August 2025
Design Development Updates

Upper Brook Street Masterplan (McLaren / Kadans)

UBS-SRA-XX-XX-RP-A-00101

This document has been produced by Sheppard Robson and proposes minor changes to the approved Sci-Tech scheme located in Upper Brook Street, Manchester.

Changes to consented external Landscape

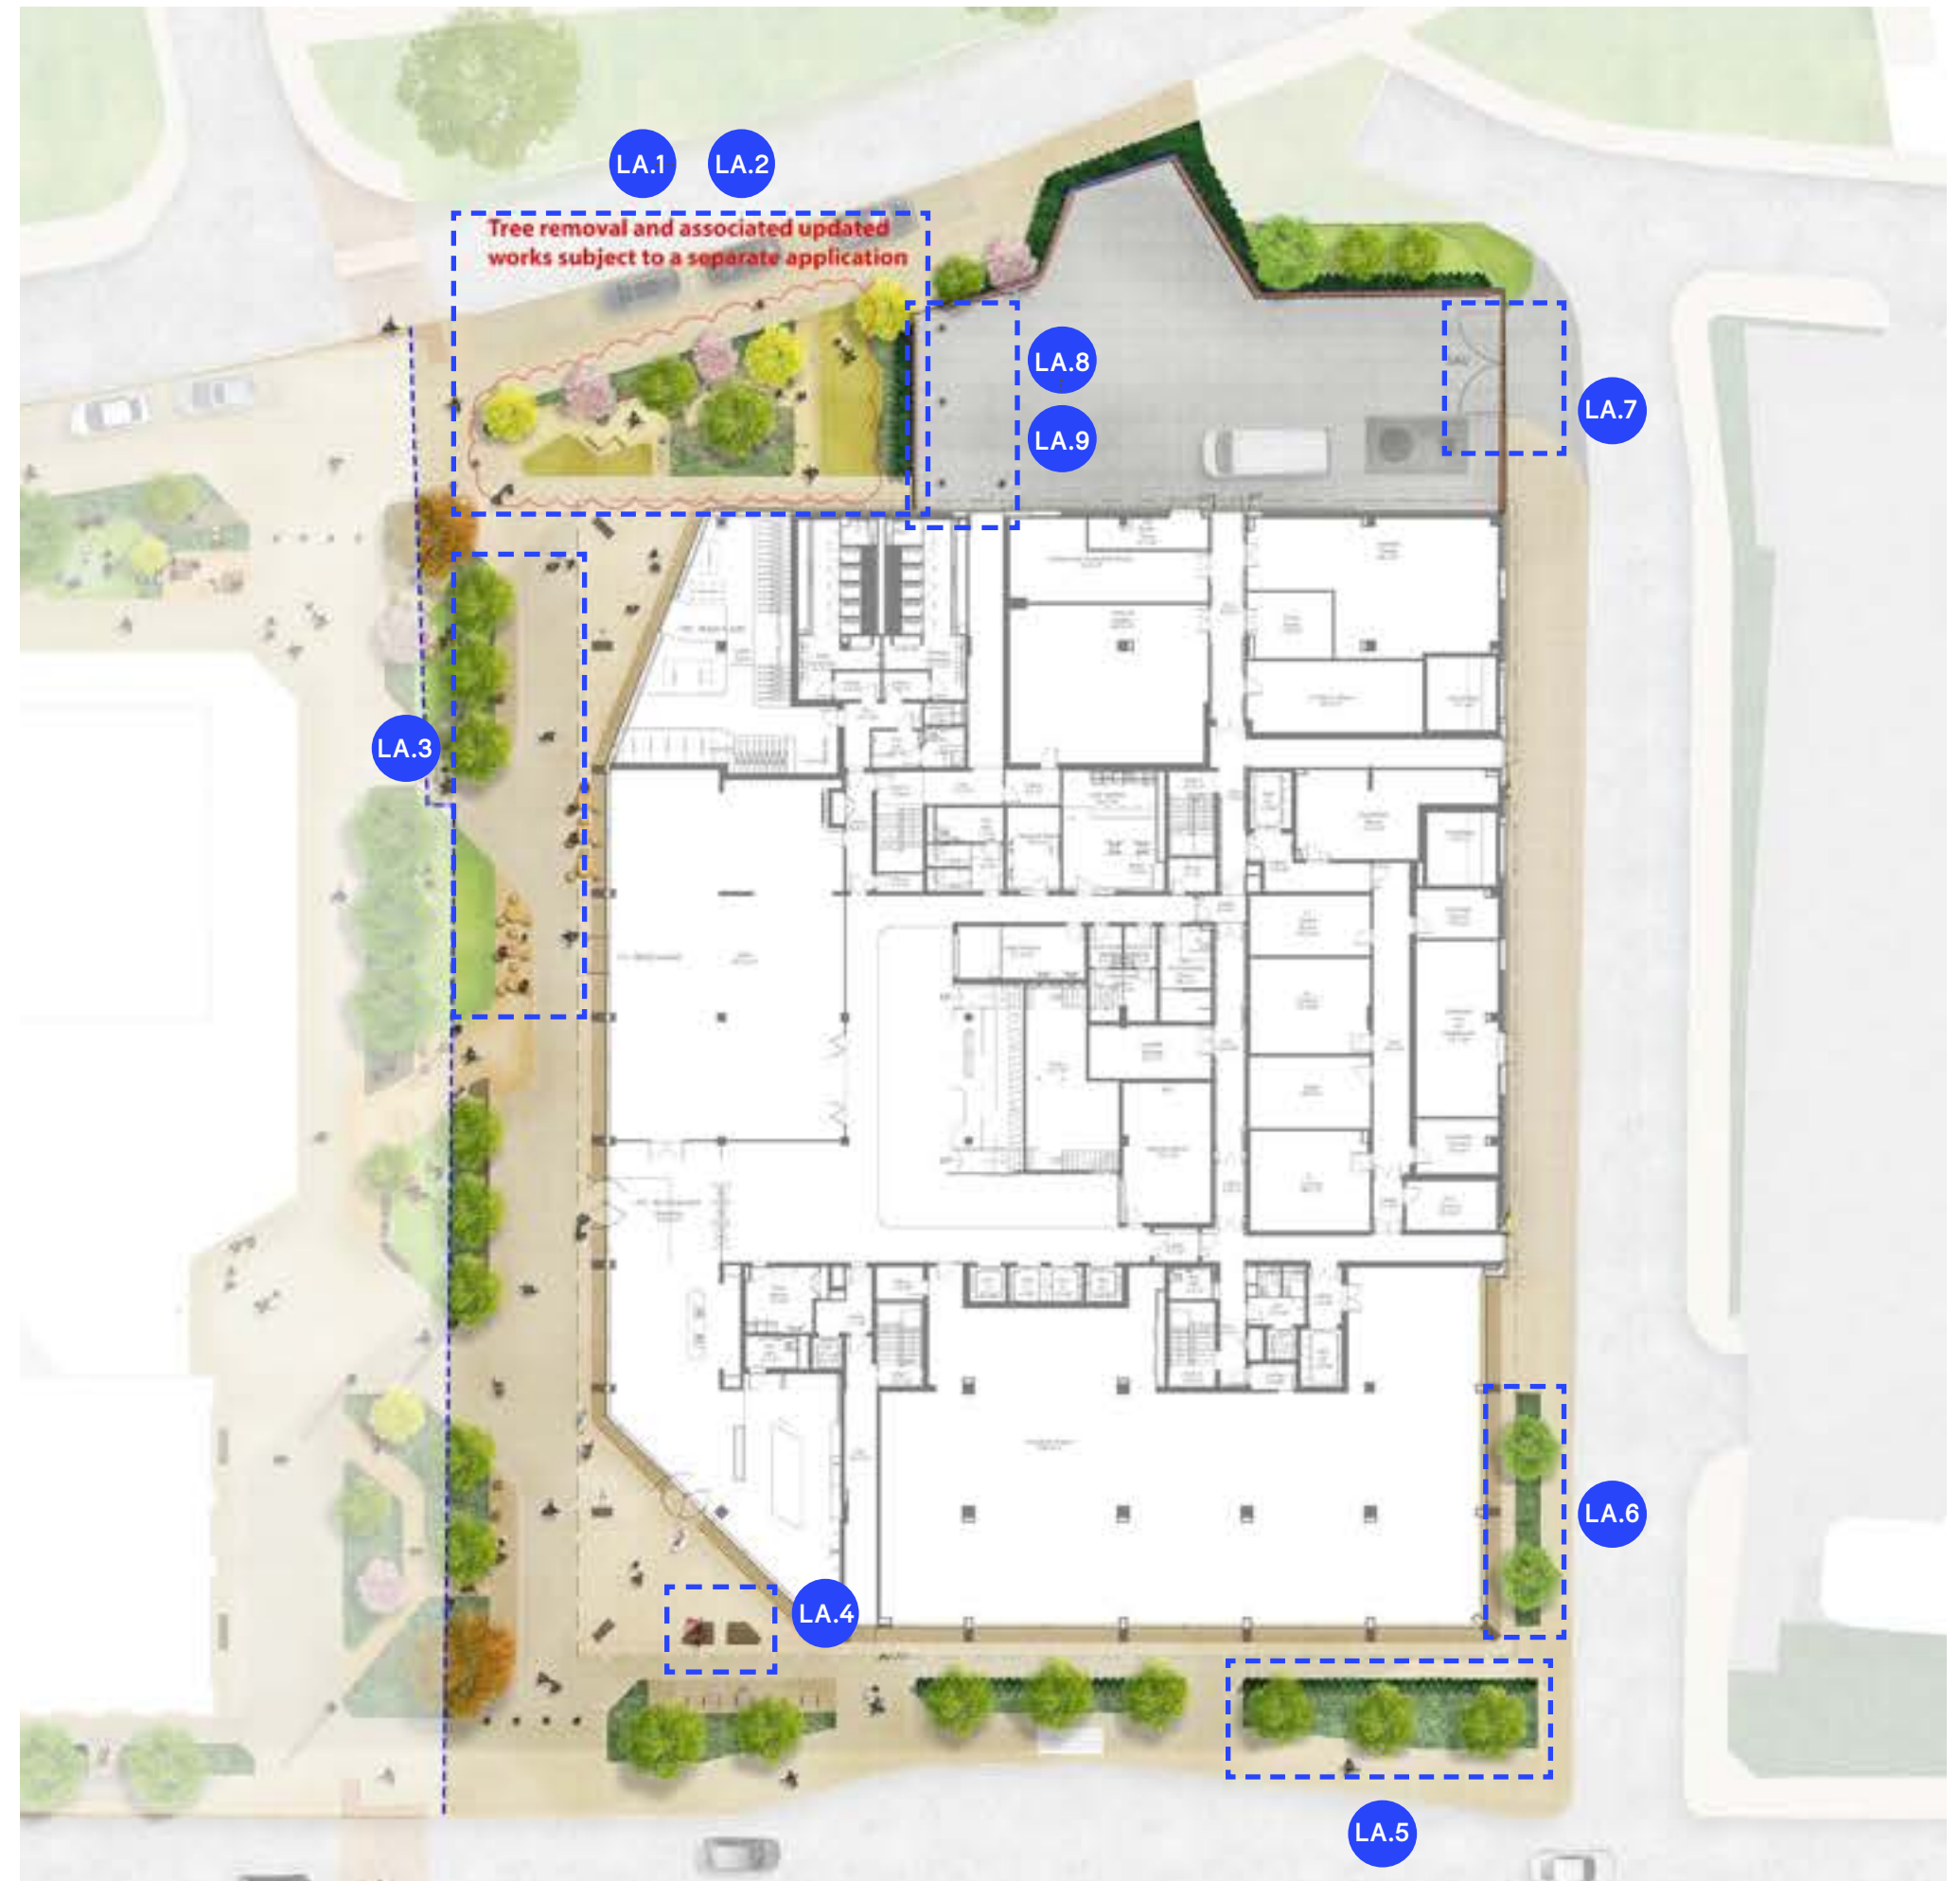
- LA.1 The informal play area design was updated.
- LA.2 Removal and replacement of tree to Kinkardine road is subject to a separate application.
- LA.3 The Thornburn walk section was updated to include 5no. additional cycle stands, the footpath along the building and the lawn area was therefore widened.
- LA.4 The seating next to the main entrance was relocated to suit accessibility requirements.
- LA.5 The soft area towards Upper Brook Street was widened.
- LA.6 The proposed tree number in Cottenham street was reduced to comply with A&M minimum clear distances.
- LA.7 The service yard entrance position was adjusted to ensure easy manoeuvring.
- LA.8 The pedestrian gate was relocated.
- LA.9 The fire escape path through the service yard was updated to suit the A&M strategy.

Change Code	Drawings Affected	Description	Design Development Justification
LA.1	0967-RFM-XX-00-DR-L-0002	Informal Play area design updated	- Position of play areas adjusted - Introduction of reinforced grass and adjustment to proposed trees positions to allow MEWP access for facade maintenance
LA.2	0967-RFM-XX-00-DR-L-0002	Removal and replacement of tree to, subject to a separate application.	Please refer to separate application
LA.3	0967-RFM-XX-00-DR-L-0002	- Thorburn walk updates to footpath width - Additional cycle parking provision - Proposed tree number increased by 1	- Updates to external cycle parking arrangements to incorporate WELL requirements - Footpath widened and position of external features updated to allow for MEWP maintenance access - Adjustment of various landscape treatments to follow the ownership boundary
LA.4	0967-RFM-XX-00-DR-L-0002	Position and design of seating in the main entrance zone updated to suit accessibility requirements.	Position adjusted to consider visual links and desire lines adjacent to the main entrance

LA.5	0967-RFM-XX-00-DR-L-0002	Soft landscape increased in size	Rationalisation of hard landscape surfacing in response to the changes within Thorburn Walk
LA.6	0967-RFM-XX-00-DR-L-0002	Proposed tree number reduced by 1	Rationalisation of proposed tree numbers following spatial coordination and to allow access for facade maintenance
LA.7	0967-RFM-XX-00-DR-L-0002	Updates to the service yard entrance position	Service yard entrance updated to allow for revisited position of gas tank
LA.8, LA.9	0967-RFM-XX-00-DR-L-0002	- General update to the position of proposed trees screening service yard - Proposed tree positions updated, tree number reduced by 2	- Update to ensure the proposed trees have sufficient space to establish - Fire escape relocated to open up onto Kincardine Road to ensure the route is free of obstruction during maintenance works
